APPENDIX C

QC and QA Construction Approval Forms and Site Correspondence

BAY-GOOSE DIKE CONSTRUCTION CHECKLIST - FOUNDATION PREPARATION and EXCAVATION

SUBJECT	Trench Excavation Survey Review: Sta 30+320 to 30+380, B-G.	
Job No. 08-1420-0029 5000	Made by [illegible] Reviewed	Date 24/06/2009 Sheet 1 of 1

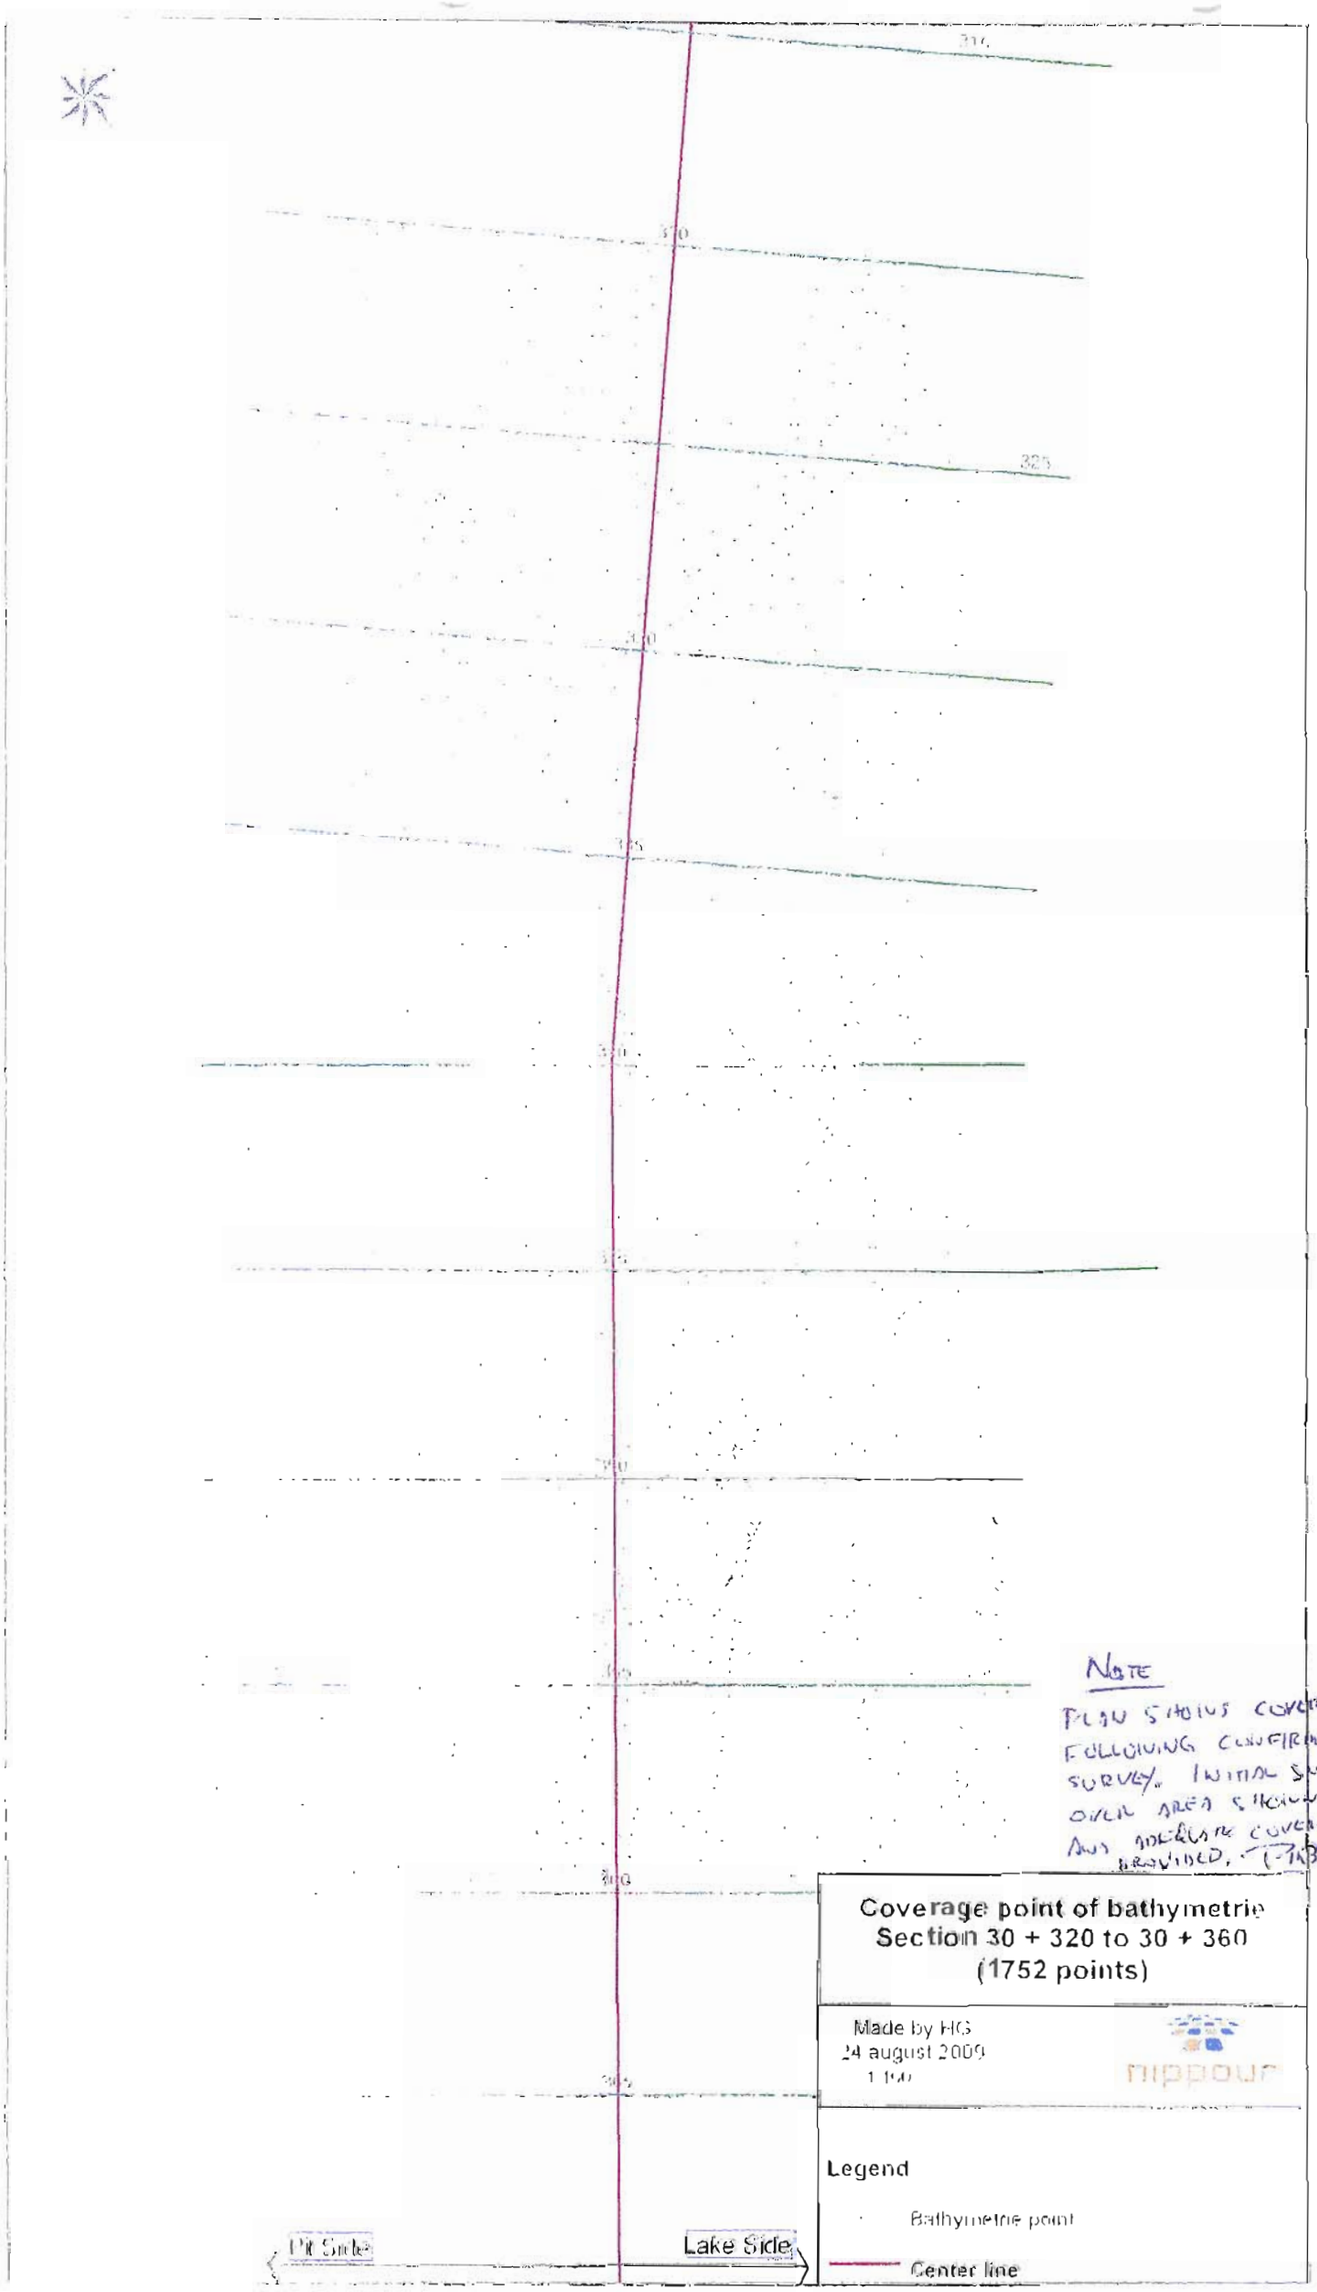
LABELED "NOT FINAL" - FINAL VERSIONS TO BE PROVIDED // FINAL VERSIONS REC'D 24/06/2009 TMB

- STA 30+365
  - STA 30+370
  - STA 30+375
  - STA 30+380 - NOT PROVIDED // PROVIDED 24 JUN 2009 TMB
  - ~~STA 30+385~~
  - ~~STA 30+390~~
  - ~~STA 30+395~~
  - ~~STA 30+400~~
- ℄ PROFILES
  - STA 30+320 to STA 30+340
  - STA 30+340 to STA 30+360
  - STA 30+360 to STA 30+380
  - ~~STA 30+380 to STA 30+400~~ ~~NOT PROVIDED~~

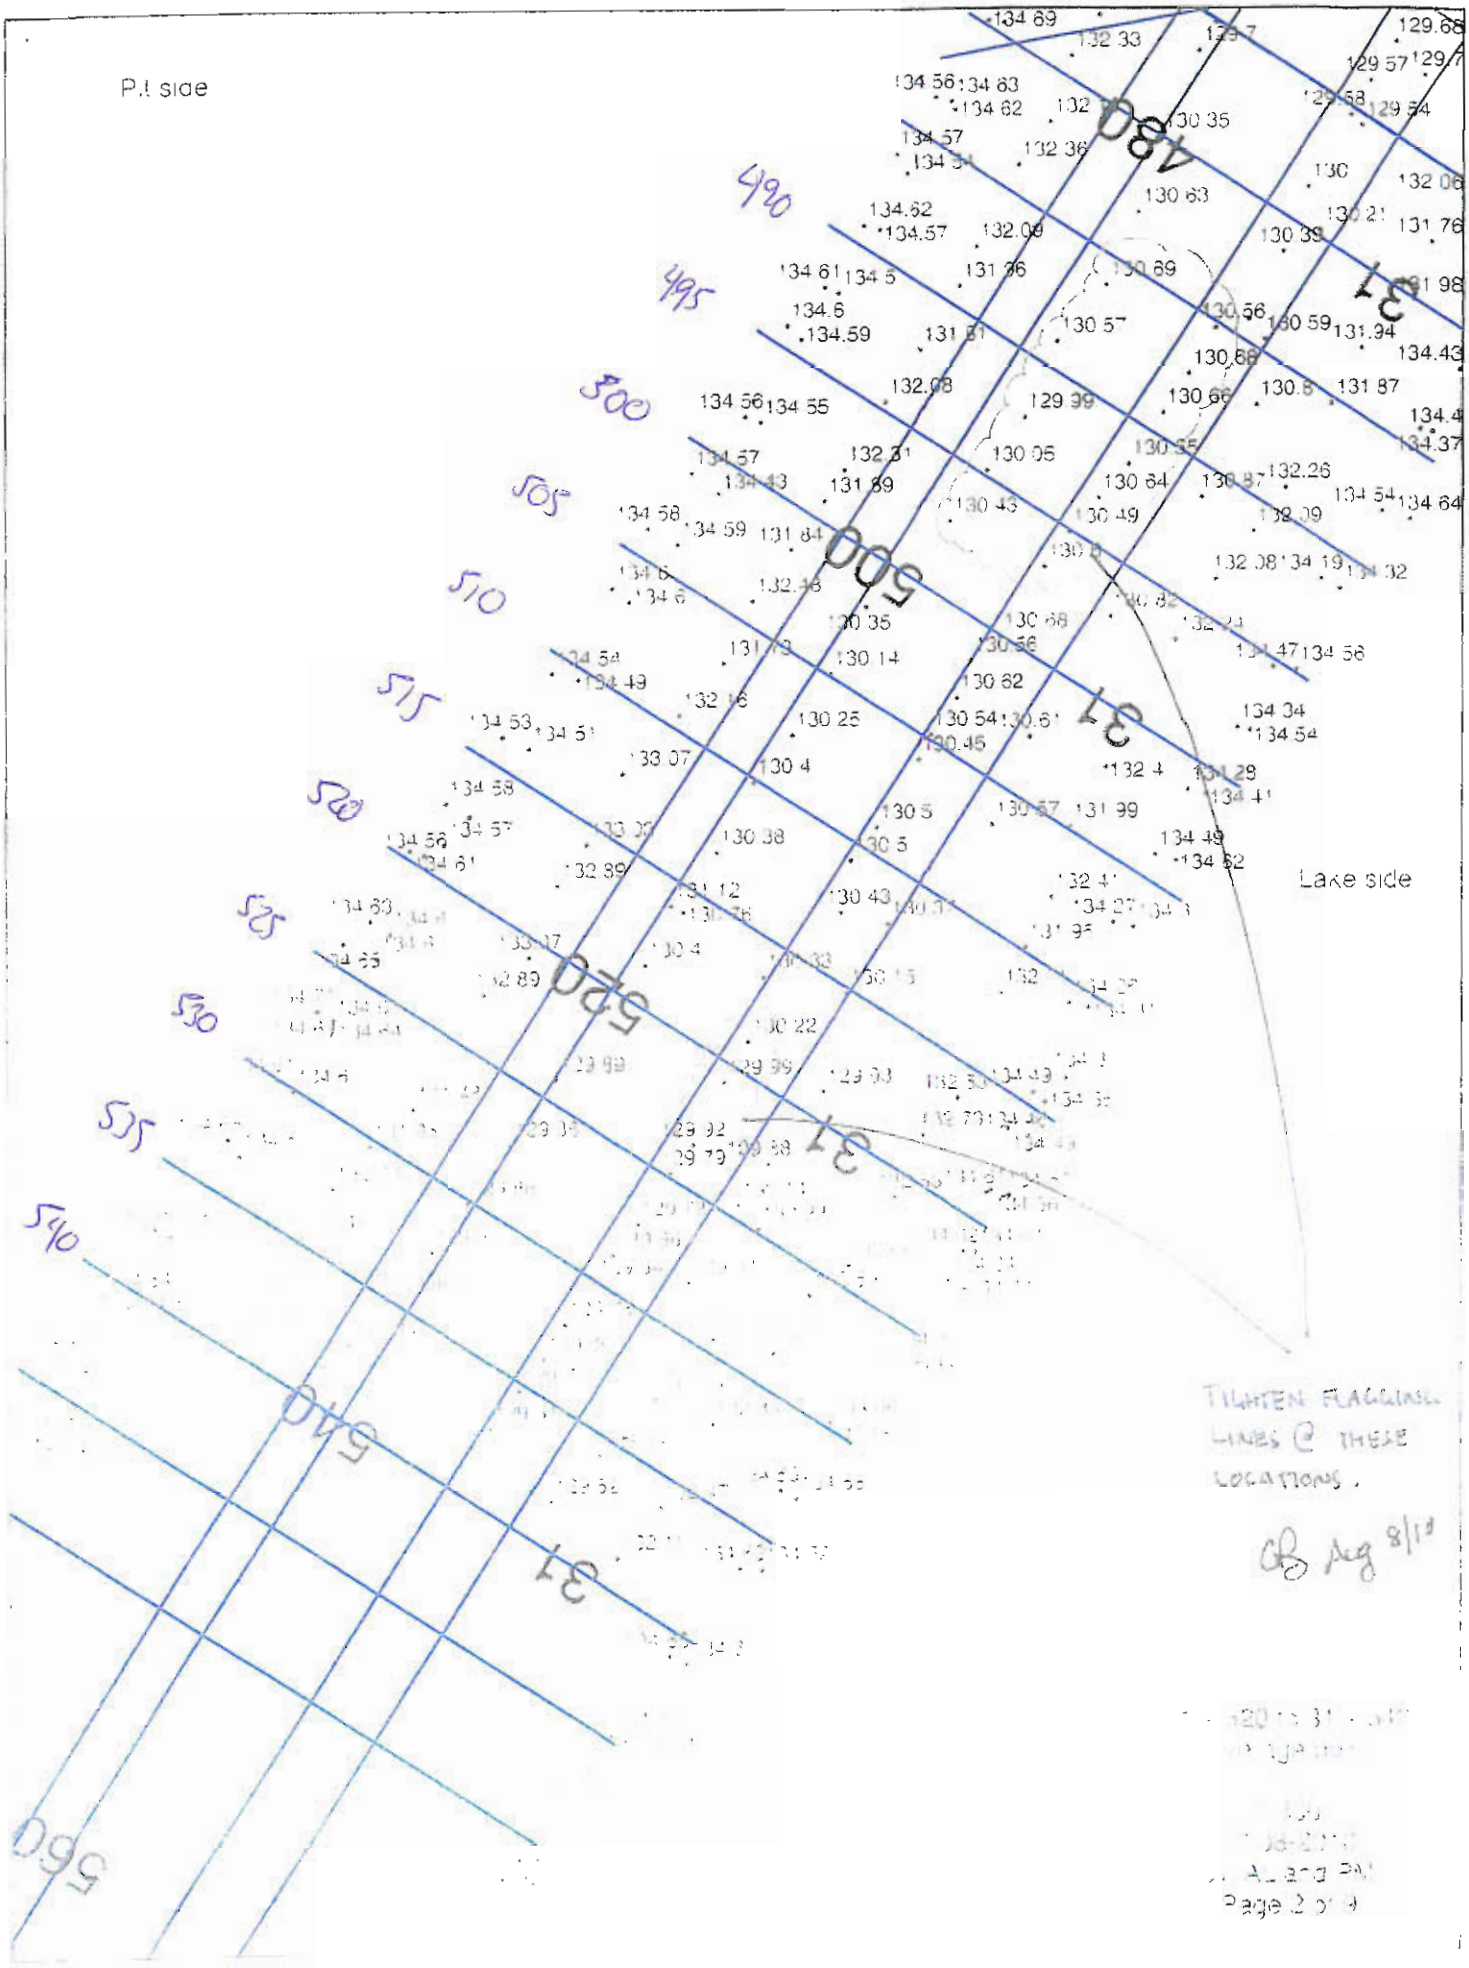
TIGHTEN FLAGGING LINES @ THESE LOCATIONS.

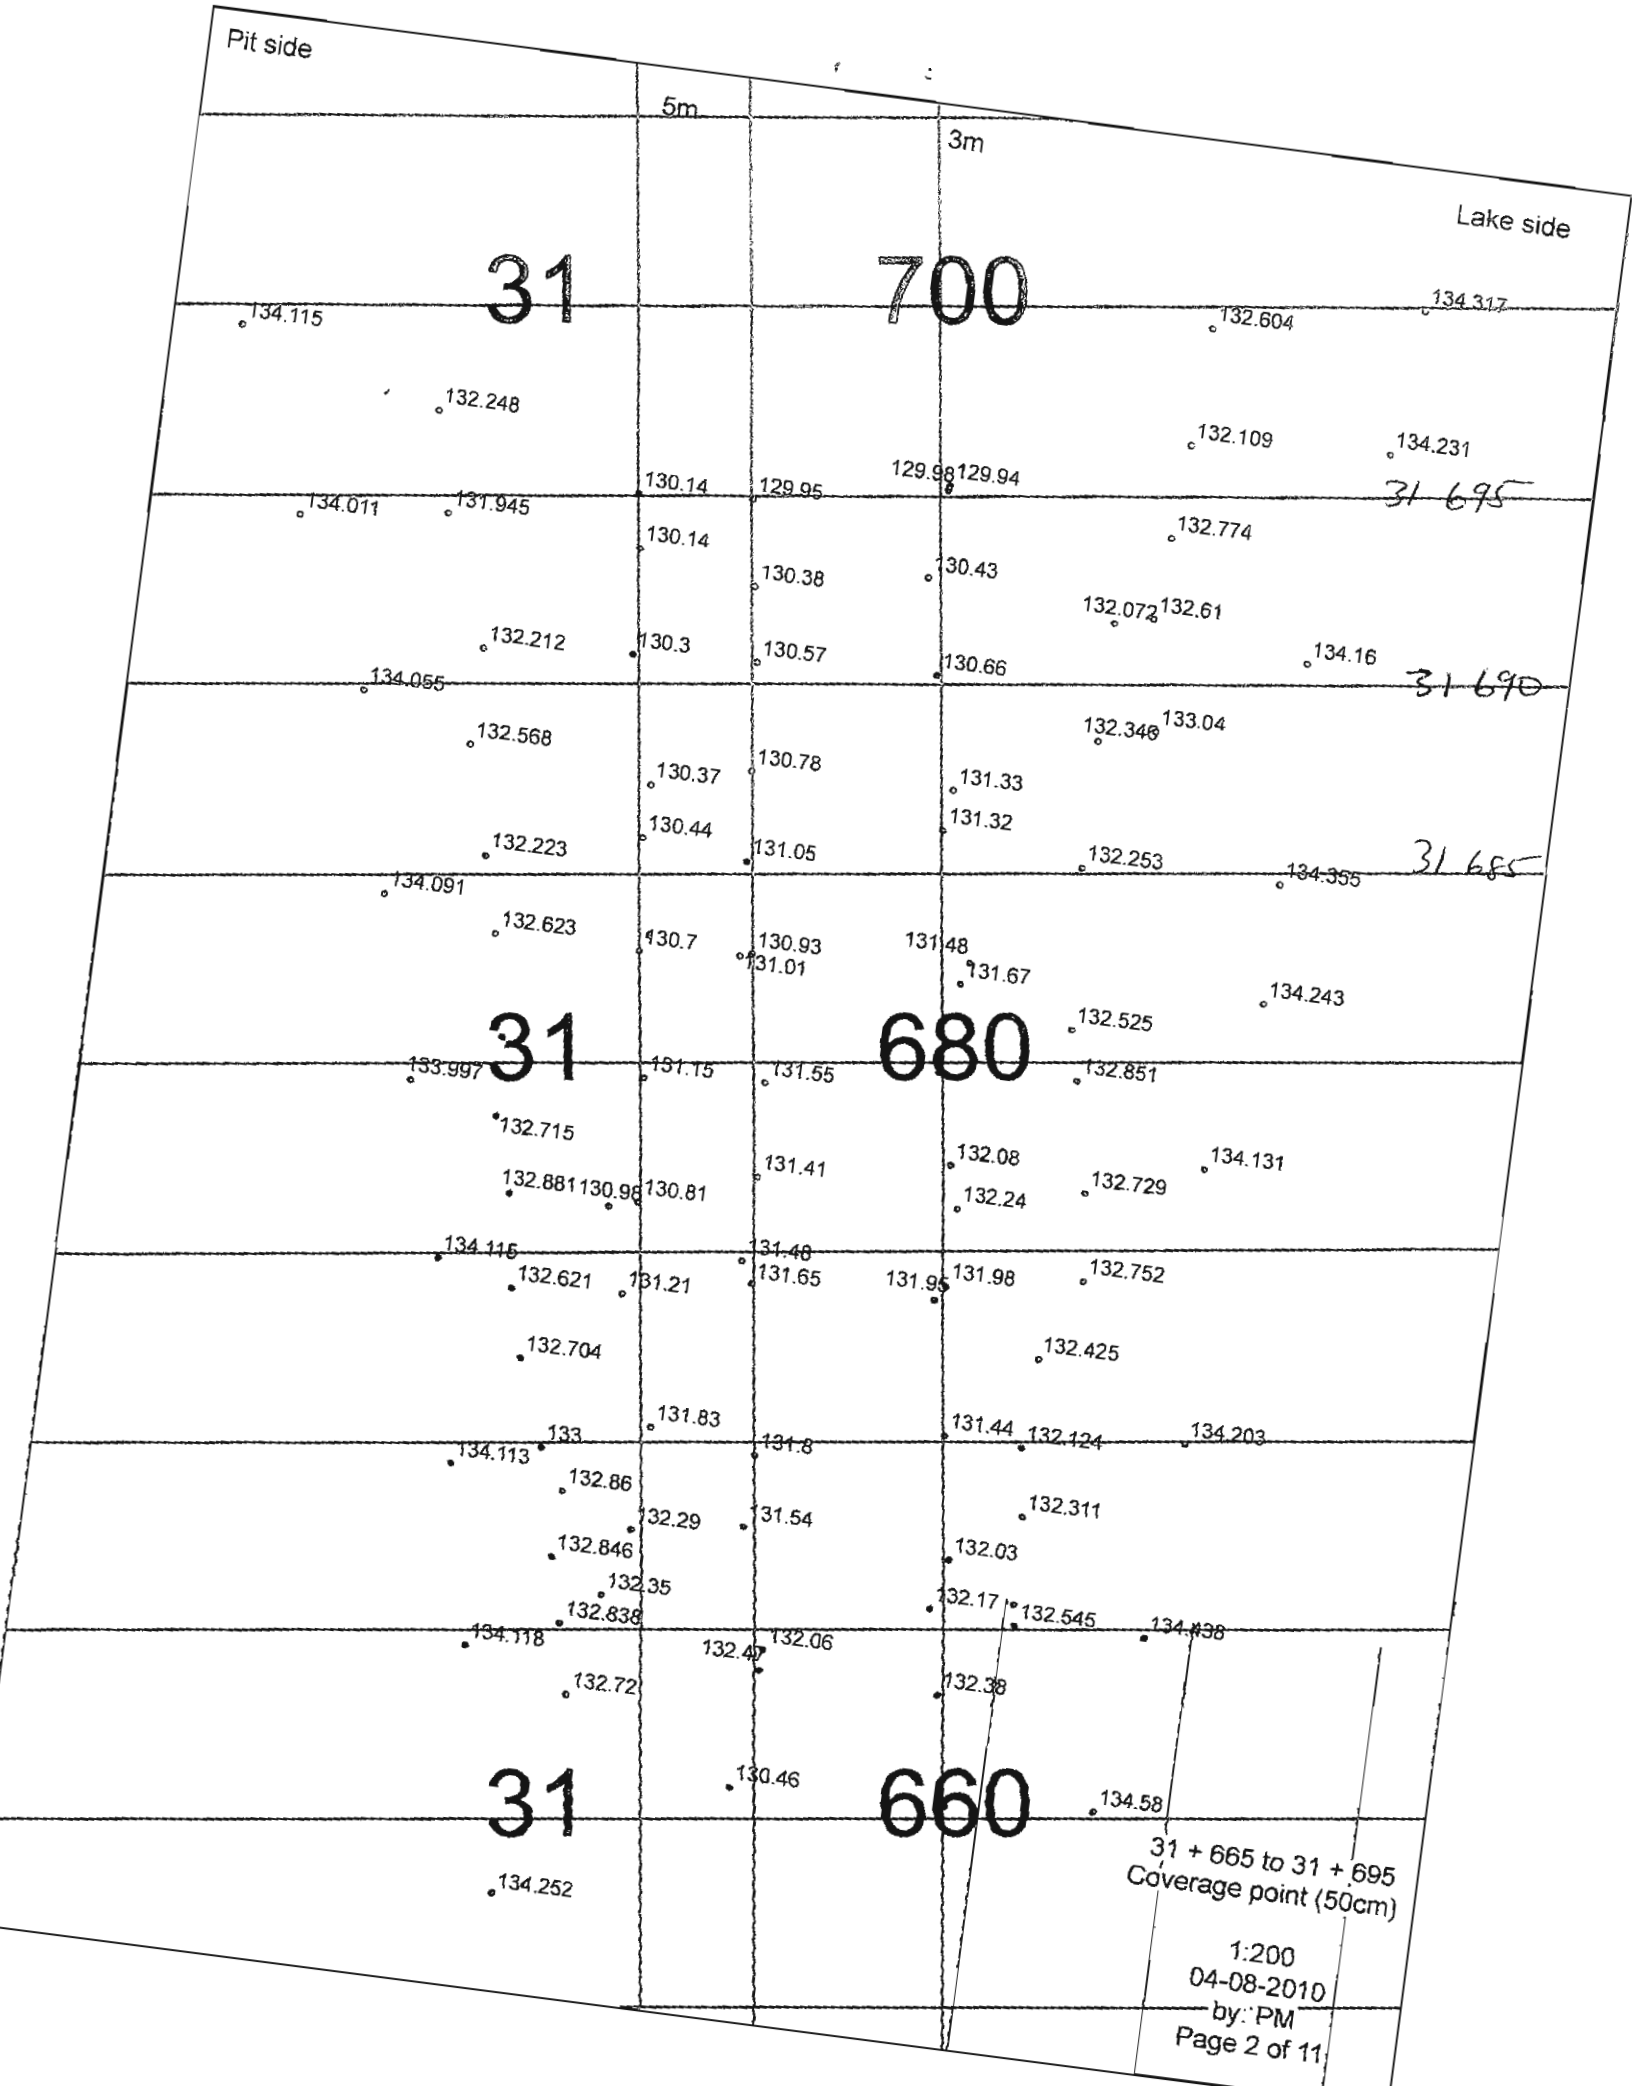
Before approving, we need the data from the soft material sounding at each 5m.

VB
Aug 4
Proceeded with Approval!
